HOLE-TYPE NOZZLES
WITH RESTRICTED
SPRAY ORIFICES

Workshop: EP
02.1992
0311 En

ROUGH IDLE
COMPLAINTS ON
1983-1984

REPAIR AND
CALIBRATION OF
PEUGEOT VE PUMPS

KMK 02143

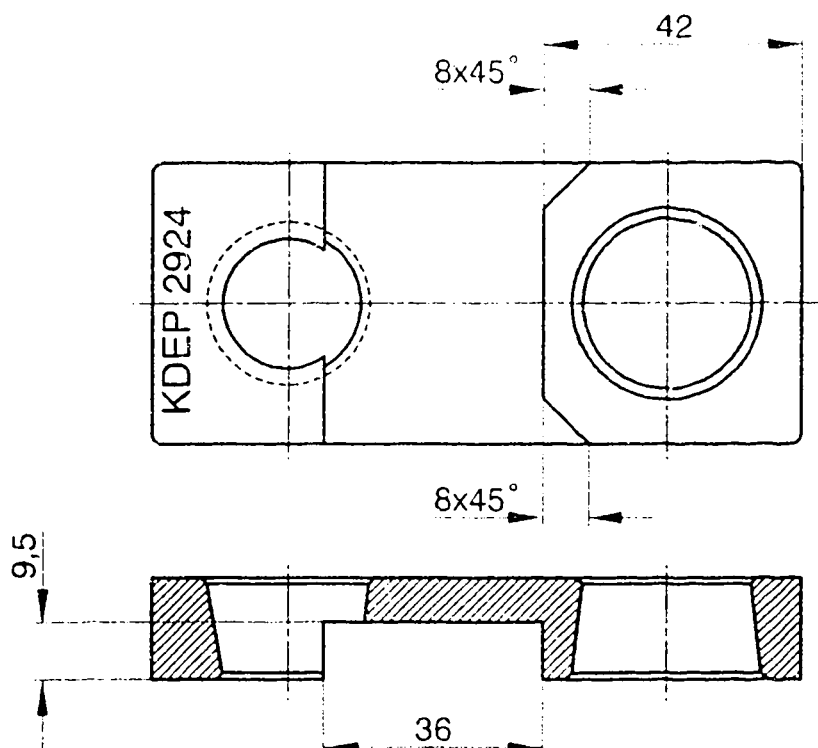
Some P-pump types are fitted on the drive end with a bearing end plate featuring a particularly wide bead for accommodating a seal ring. With these pumps, it is not possible to use the gauge KDEP 2924 in its original form for calibrating the camshaft projection.

The following diagram shows how the gauge is to be modified, so as to enable it to still be used with the fuel-injection pumps already described. Newly supplied gauges KDEP 2924 have already been modified.

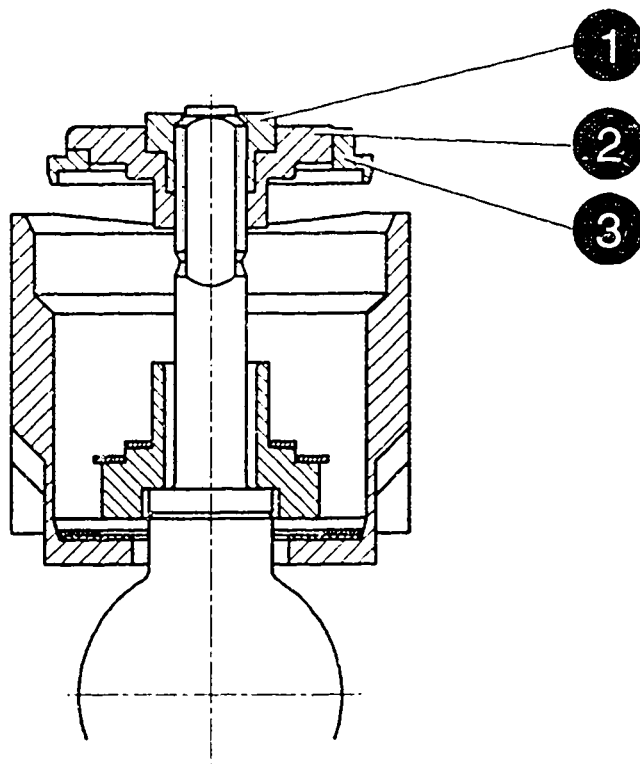
A 2-piece spring seat is being gradually introduced to facilitate adjustment of the flyweight springs on RQ(V) governors.

This new 2-piece spring seat makes for independent adjustment of the pretension of the idle spring on the one hand and the center/inner spring on the other.

As a result, the upper rated speed is no longer affected when setting/adjusting idle.

On assembling the governor, the split spring seat is to be installed such that the driver pins of the spring seat engage in the center stage of the adjustment ring marked with a notch. For idle adjustment, the adjustment tool KDEP 1634 is used to press the adjustment ring of the split spring seat against the idle spring until its teeth are disengaged from the spring-seat pin.

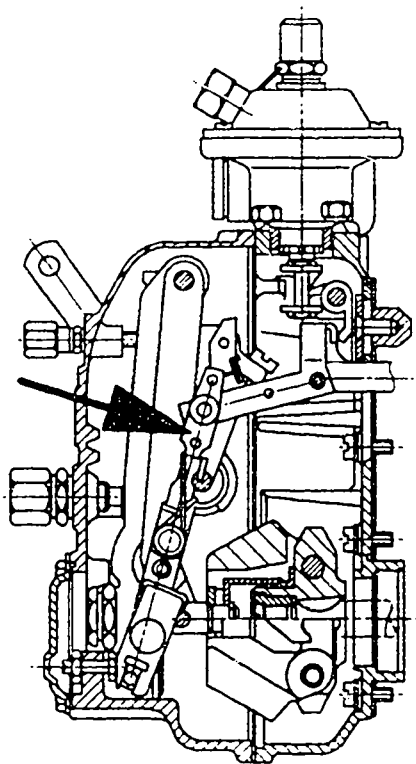
Such unsatisfactory adjustment quality was due to the fact that the deflection element in the inner stop lever is subject to considerable friction. The hysteresis thus produced in the LDA characteristic curve does not permit defined adjustment. As the pressure over the LDA diaphragm decreases, the clearances and elasticities in the governor compound lever are offset before the initial tension of the spring in the deflection element is overcome.

A deflection element was integrated into the fulcrum lever of such governors as a design remedy. This fulcrum lever is known as "buckle lever".

The deflection element in the fulcrum lever is of the low-friction type and requires far less initial tension than the deflection element in the inner stop lever.

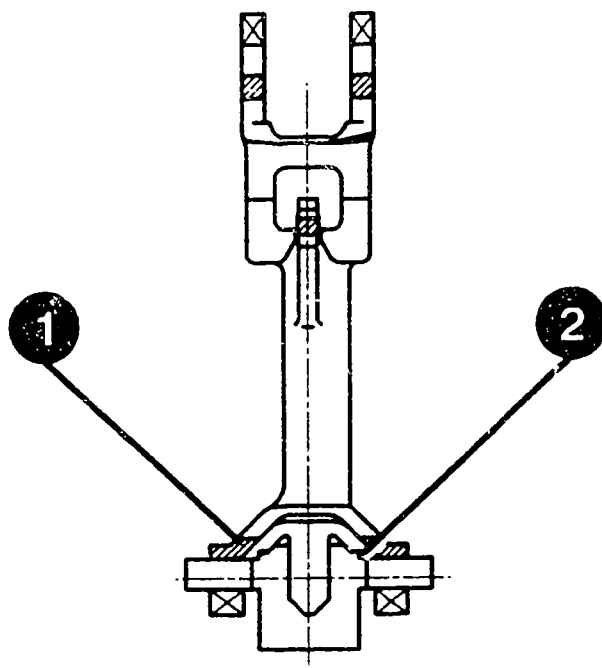
If, on replacing a fulcrum lever, it is established that this makes contact as shown with the sliding block, DO NOT ALTER THE FULCRUM LEVER IN ORDER TO CREATE A SPACE, but rather replace the sliding block with part no. 2 422 130 038.

Fig. a = GDV barrel valve

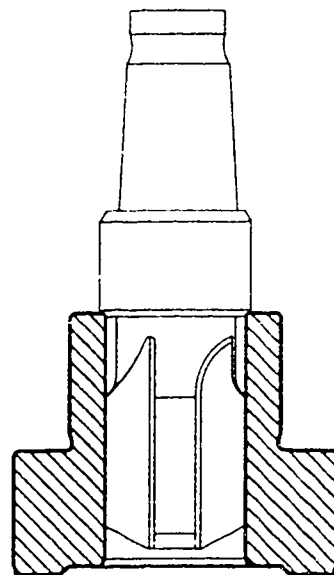
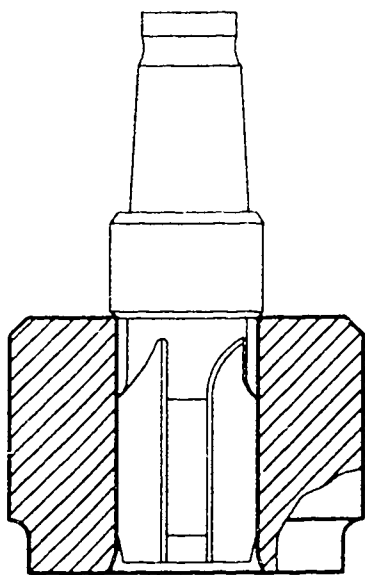
This valve holder is designed to replace the collar-valve holder previously used as standard.

KMK04724

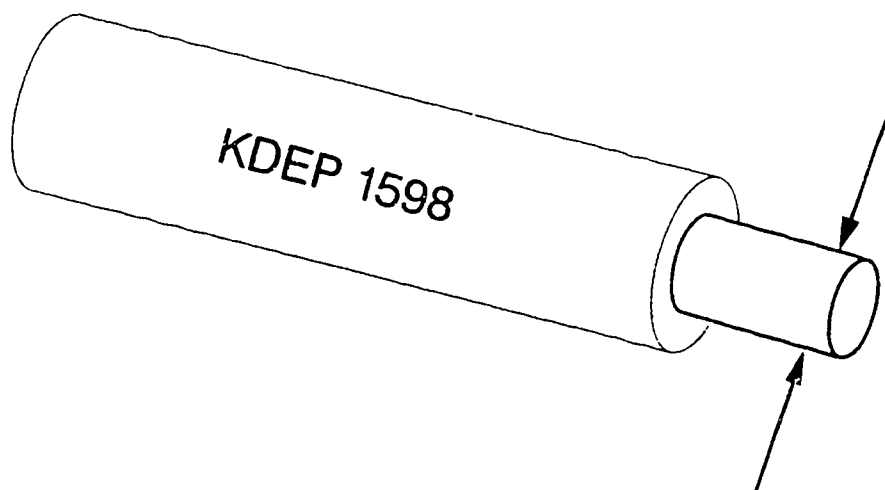
An increase in the wall thickness of cup plug 1 410 505 012, used for sealing the roller tappet lifting tool access bore, has necessitated a reduction in the diameter of insertion tool KDEP 1598. See illustration.

Reduce the diameter of the pilot pin by 0.4 to 0.5 mm to a diameter of 10.0 - 0.1 mm.

This will enable the tool to be more easily withdrawn from an inserted cup plug and will prevent the possible cracking of the pump housing during the cup plug insertion process. The modification of this tool will not affect its use on cup plugs made prior to the change.

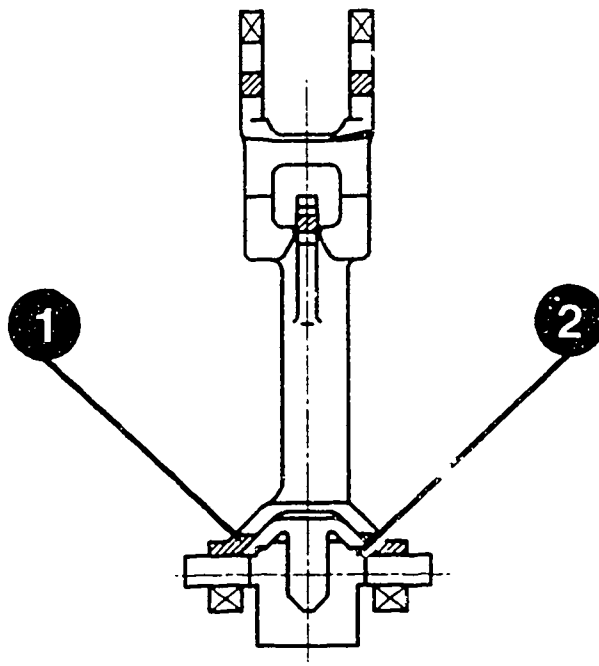
If upon replacement of a fulcrum lever you encounter an interference with the sliding block as illustrated below, DO NOT MODIFY THE FULCRUM LEVER TO OBTAIN CLEARANCE. Replace the sliding block with part number 2 422 130 038.
